**R66 SERVICE LETTER SL-06**

**SUBJECT:** Damper Assembly

**ROTORCRAFT AFFECTED:** R66 helicopters S/N 0003 thru 0197.

FIGURE 1

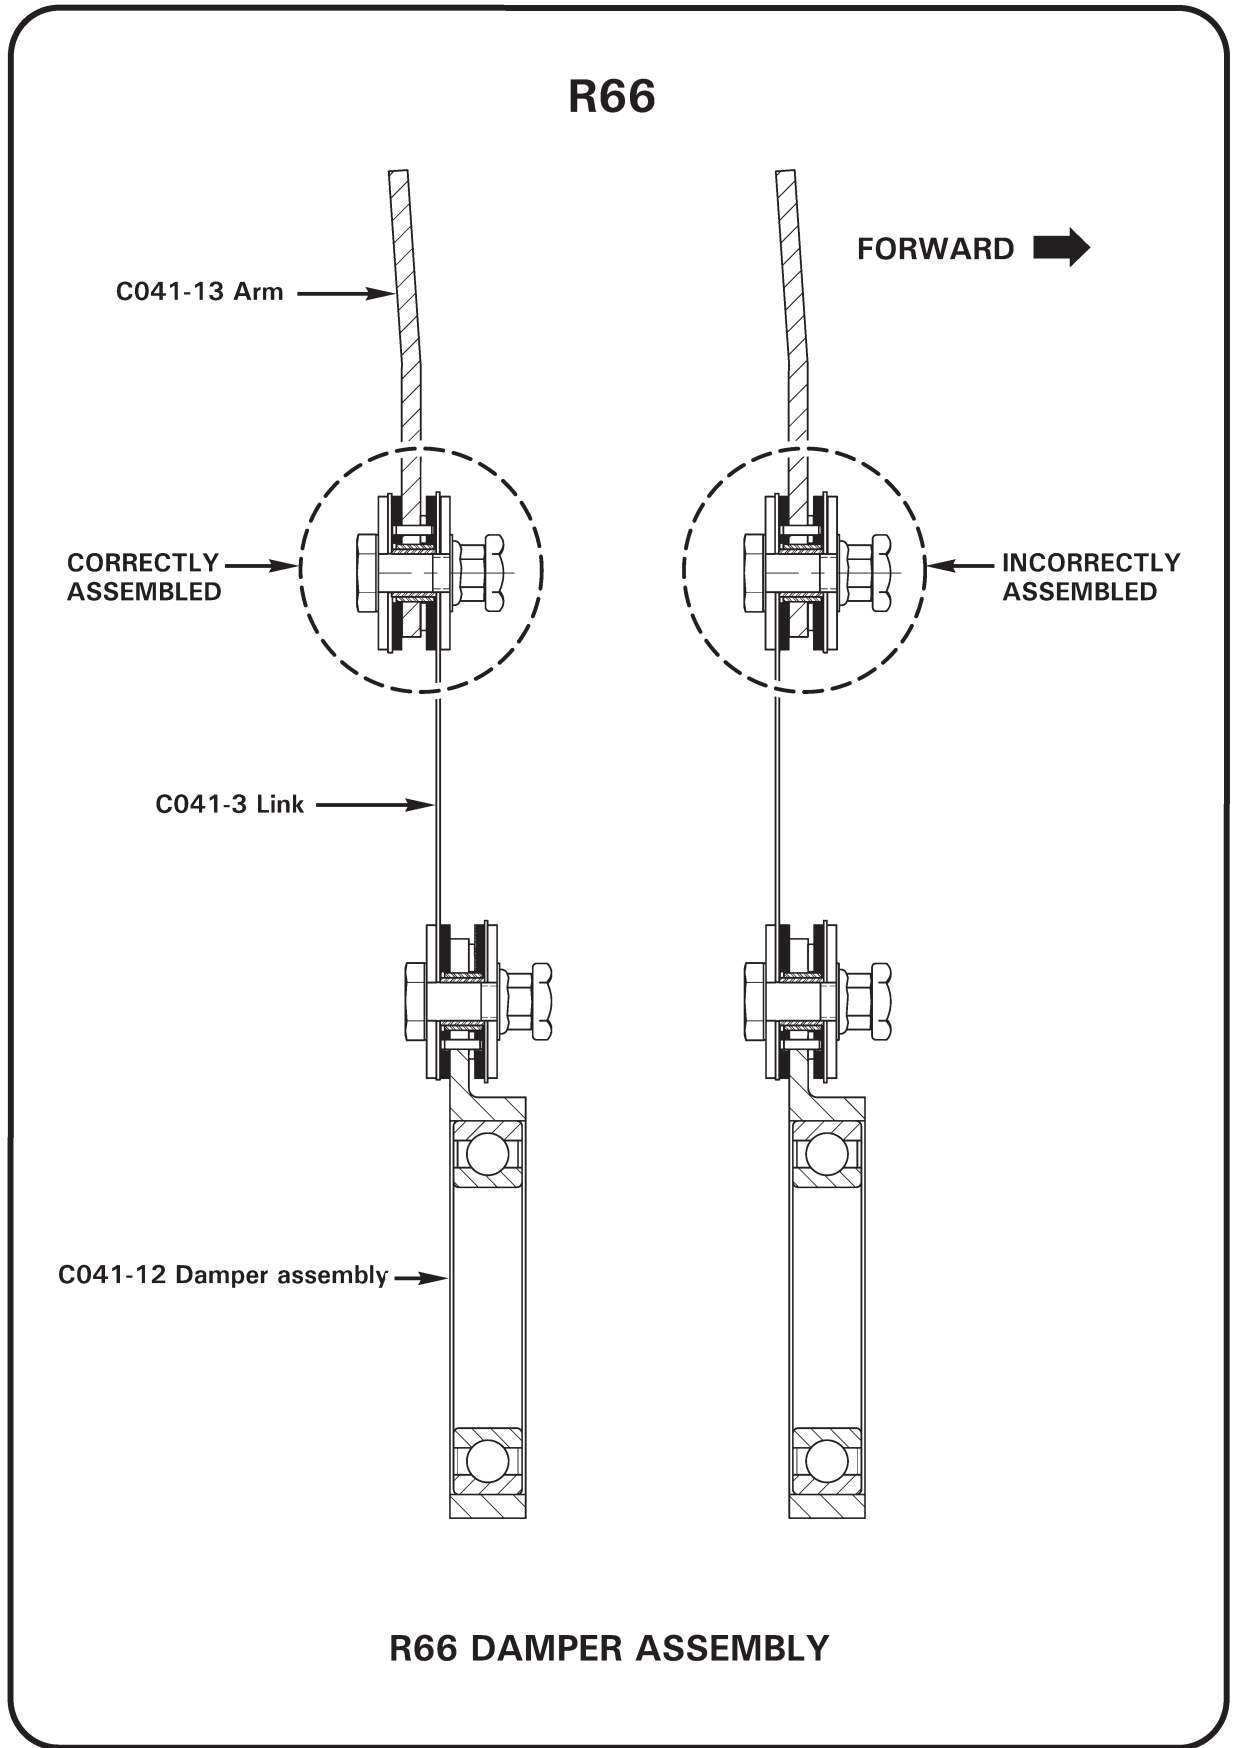
**BACKGROUND:** Some tail rotor drive shaft damper assemblies were assembled incorrectly during production. RHC recommends correcting affected dampers at next tail rotor drive shaft removal and installation.

1. Remove tailcone assembly's forward A231-1 inspection plug.
2. Refer to Figure 1. If C041-12 damper assembly's C041-3 link is installed forward of C041-13 arm, reinstall inspection plug; no further action is requested.
3. If damper's C041-3 link is installed aft of C041-13 arm, reinstall inspection plug and remove tail rotor drive shaft assembly per R66 Maintenance Manual (MM) § 65-20.
4. Disassemble, inspect, and correctly assemble damper per MM § 65-22.
5. Install tail rotor drive shaft assembly per MM § 65-20.
6. Make appropriate maintenance record entries.
